**Planned Unit Development & Replat – Lot 19
Southport West and Lots 1, 2, and 3 Southport
West Replat Seven – Southport Parkway, LLC**

**CITY OF LA VISTA
PLANNING DIVISION
RECOMMENDATION REPORT**

CASE NUMBERS: PPUD21-0001;

Staff Review Letters

SHEET L.1.1

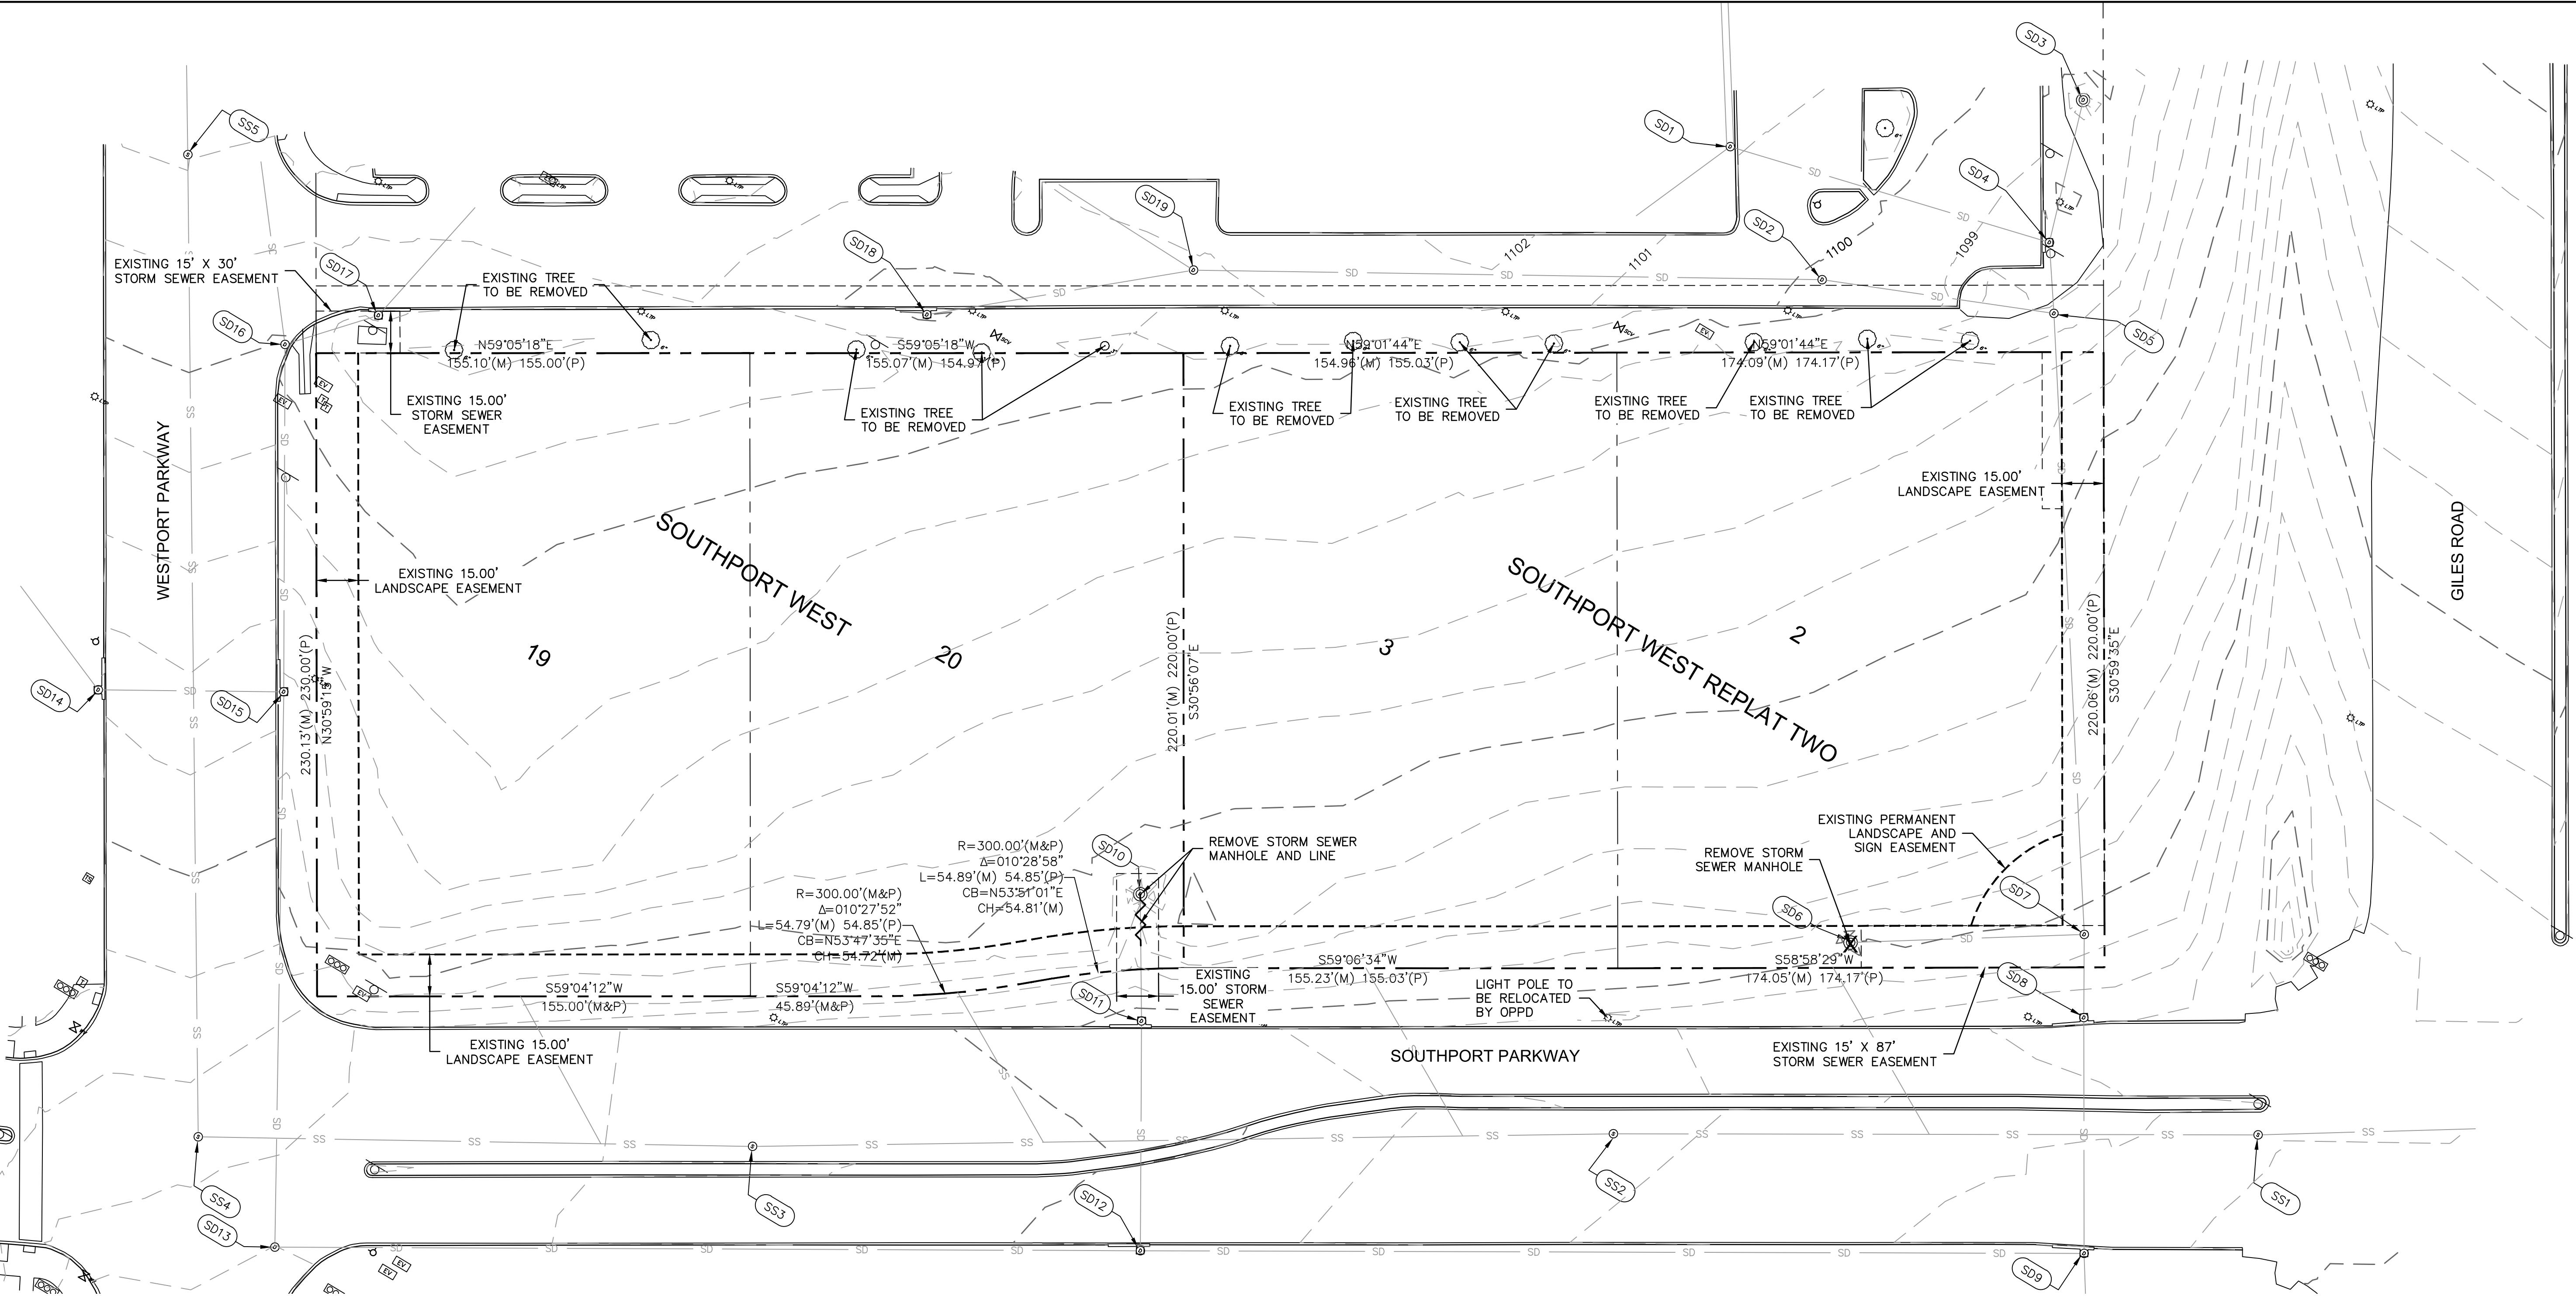
- c. With the relocation of the access along Southport Parkway and the subsequent relocation of the sidewalk, several trees depicted in the landscaping plan on proposed Lot 2 appear to conflict with the location of the sidewalk. We recommend moving these trees east in some arrangement, as noted in the attached redlined landscaping plan.
3. The revised landscaping plan is currently under review by the City's Design Review Architect. A separate design review letter will be forwarded once the follow-up review has been completed. Final approval of the landscaping plan will be required prior to City Council review.
